UNITED STATES OF AMERICA
NUCLEAR REGULATORY COMMISSION
ATOMIC SAFETY AND LICENSING BOARD

SEQUOYAH FUELS CORPORATION
and GENERAL ATOMICS

(Gore, Oklahoma Site
Decontamination and
Decommissioning Funding)

AFFIDAVIT OF TIMOTHY P. BROWN

Schematic of SFC Site and Important Local Features

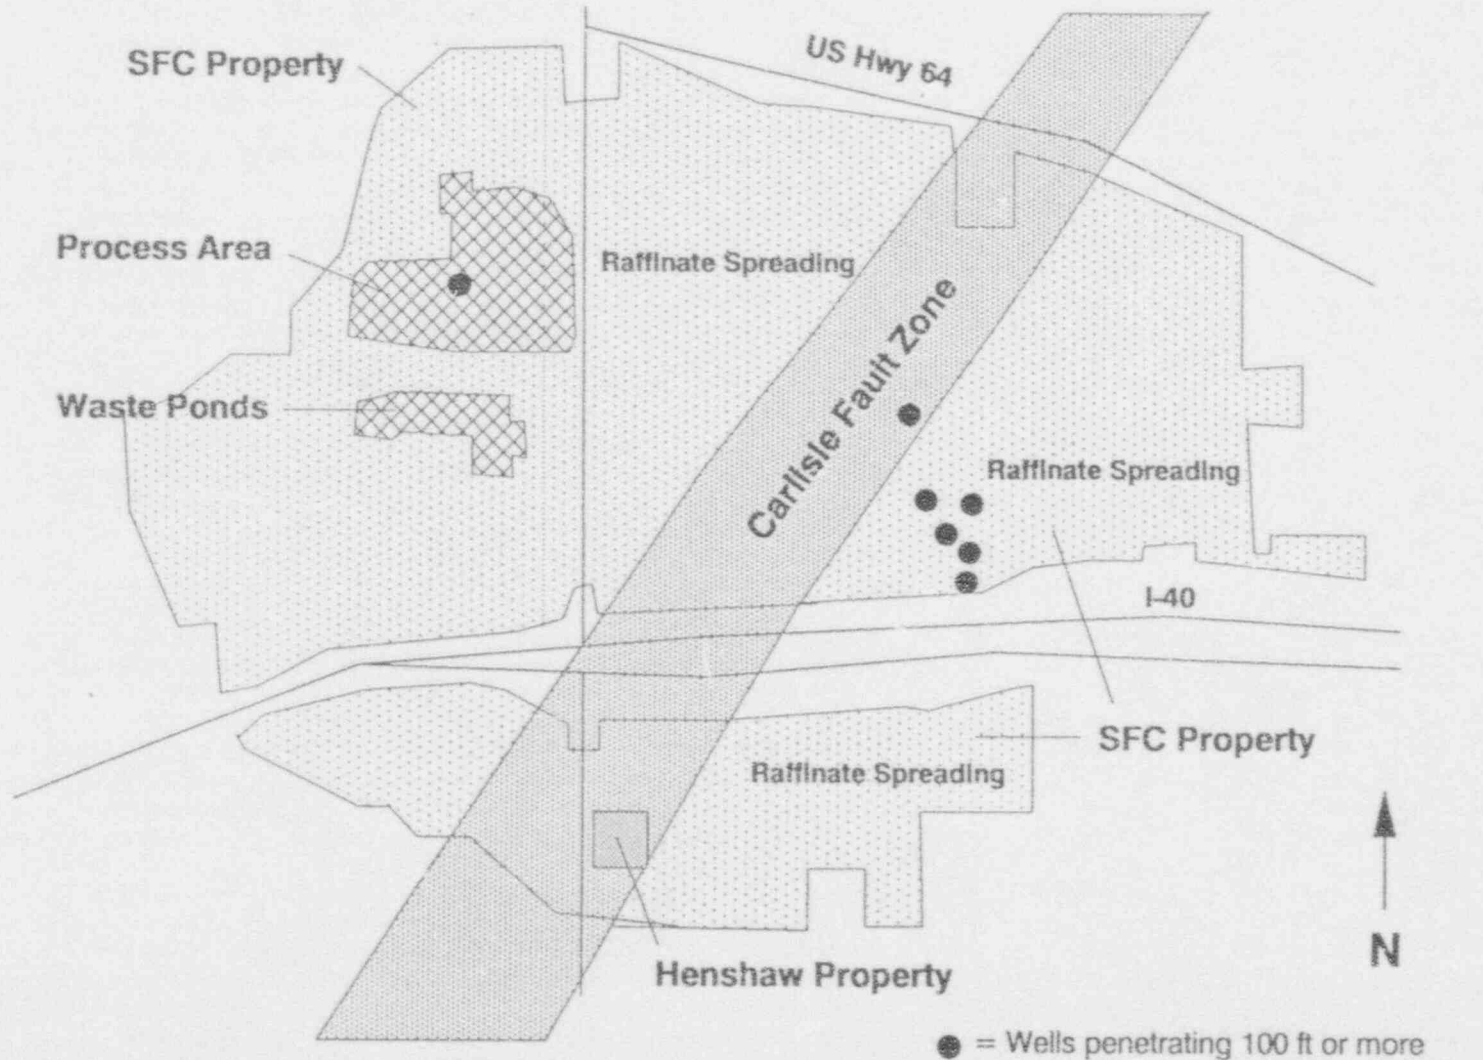
10. Mr. Henshaw's property may also be susceptible to contamination from SFC's raffinate spreading fields which adjoin his property on several sides (see Attachment 1). Raffinate is a highly concentrated nitrate solution containing heavy metals including arsenic, barium, mercury, lead, selenium, uranium, and others. SFC's Fertilizer Completion Reports have indicated that levels of nitrates and cadmium have at times been above the Environmental Protection Agency's drinking water limits, and that levels of gross alpha emission and uranium have been above the currently proposed EPA limits for radioactive substances (see: Sequoyah Fuels Corporation, Ammonium Nitrate Fertilizer Program, 1989 Completion Report, April, 1990). Data collected relating to groundwater quality in the raffinate spreading areas are extremely limited, so that the effects of SFC's raffinate spreading program on groundwater quality have not been fully determined. Several of these fields are eastward of Mr. Henshaw's property. Thus Mr. Henshaw's property is at risk of contamination whatever direction groundwater flows in the area.

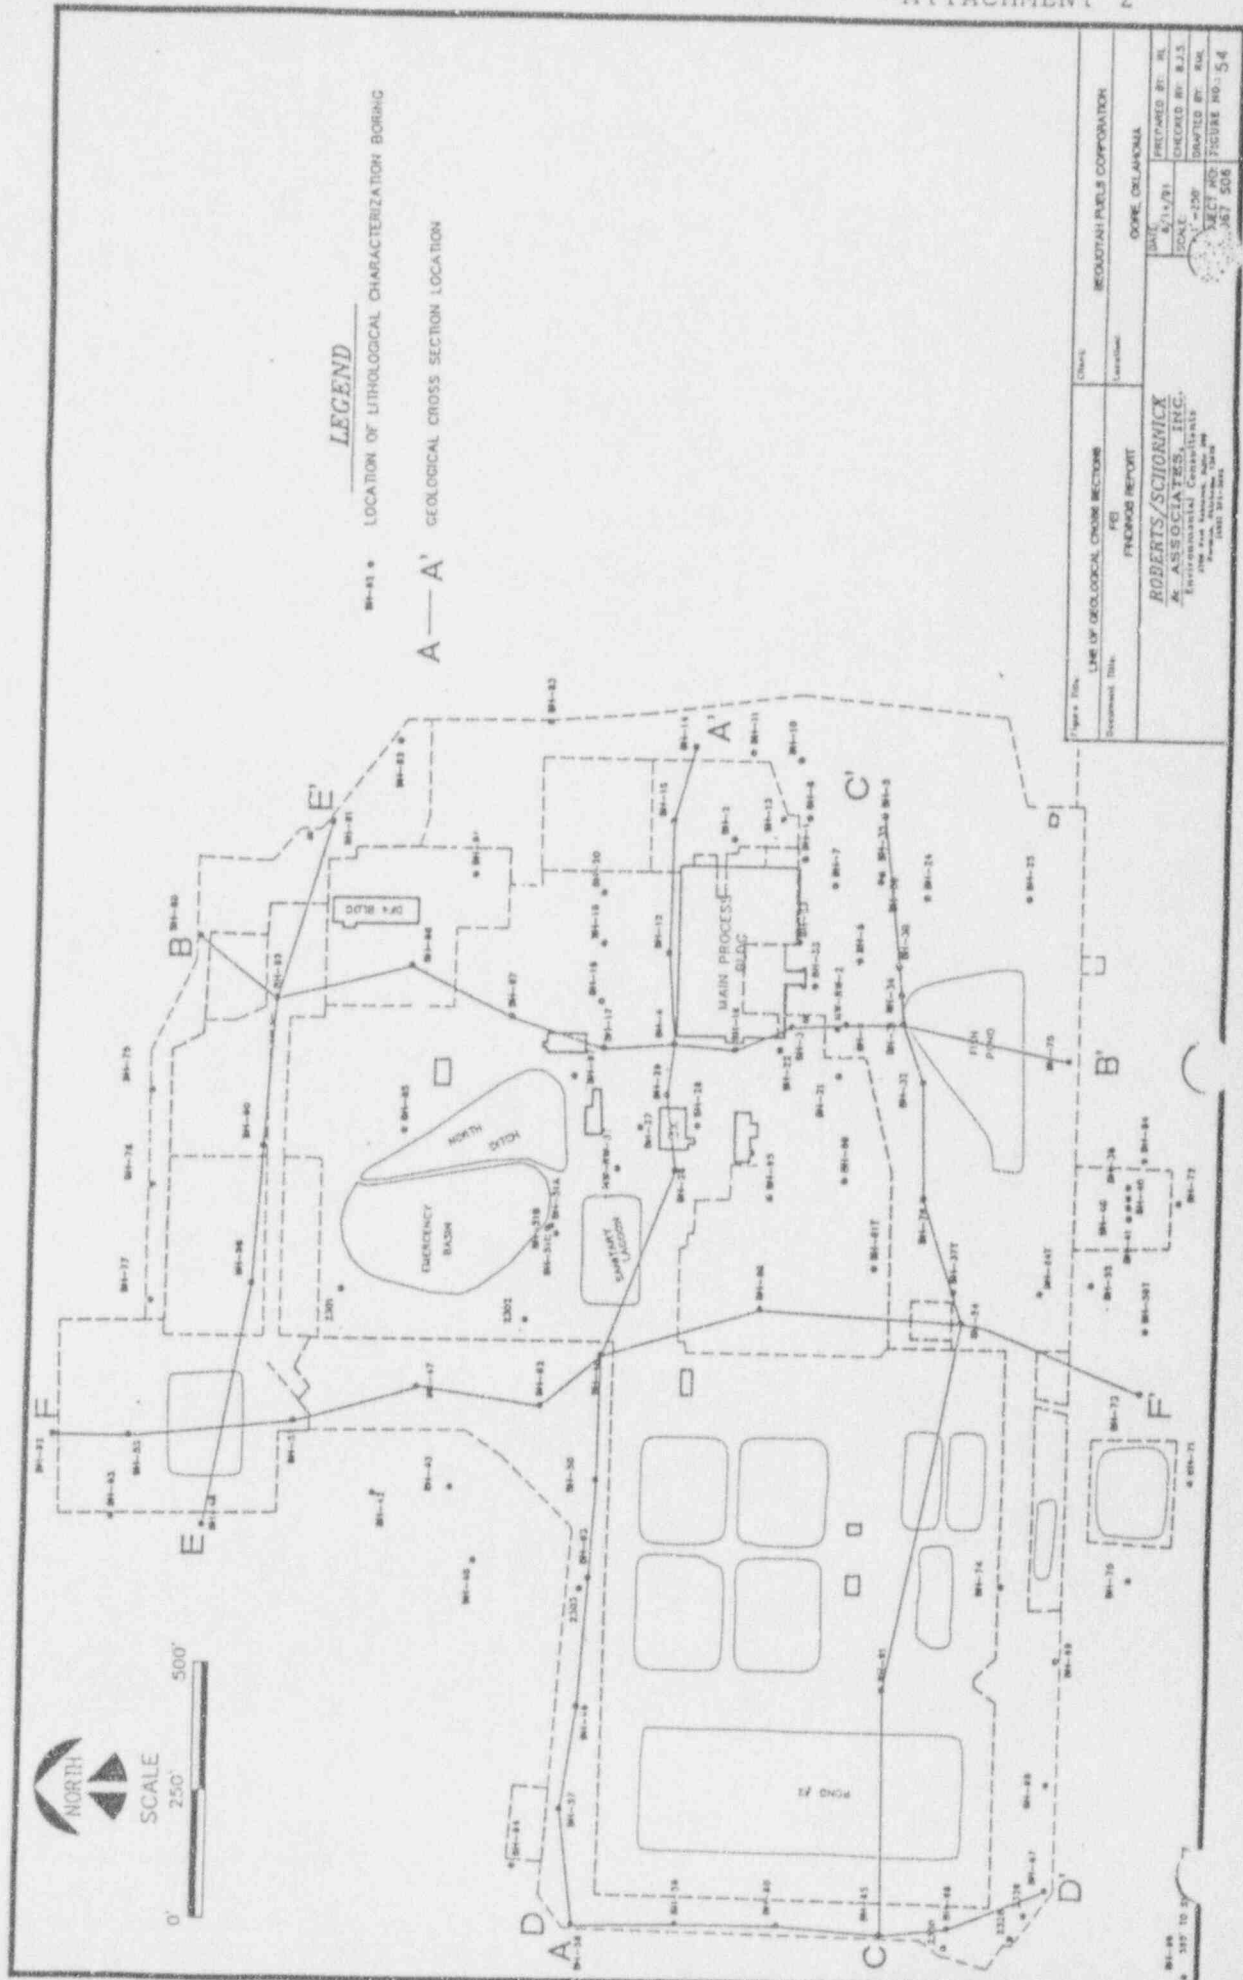
the impoundments to the south. These two areas represent a small portion of the larger flow field at the SFC Gore site and are insufficient to characterize, with reasonable confidence, groundwater flow which could affect Mr. Henshaw's property. Figures 48 through 54 of the FEI (Attachments 2-8 to this Affidavit), which show geologic cross-sections of the area, reveal a complex and unpredictable pattern of hydrologic unit relationships. There exist many juxtaposed rock units which exhibit a wide range of hydrologic properties. As water flows through these dissimilar rocks, flow direction may bend and twist as the pressure field accommodates sharp changes in conductivity and porosity.

- b) In addition, several site maps, including Kerr-McGee Corporation's Site Plan and Area Map #110-C-151, Rev. 5, (Attachment 9 to this Affidavit), show a fault zone running from roughly the old Carlisle School, due east of the processing area, through Mr. Henshaw's property south of the site. This fault zone contains groundwater and likely plays a significant role in the area hydrodynamics. It may act as a fast pathway or as a barrier to groundwater flow. Data collection and analysis has not been performed to determine the impact of the fault, as SFC's efforts have concentrated on the immediate area of the processing buildings and waste ponds.
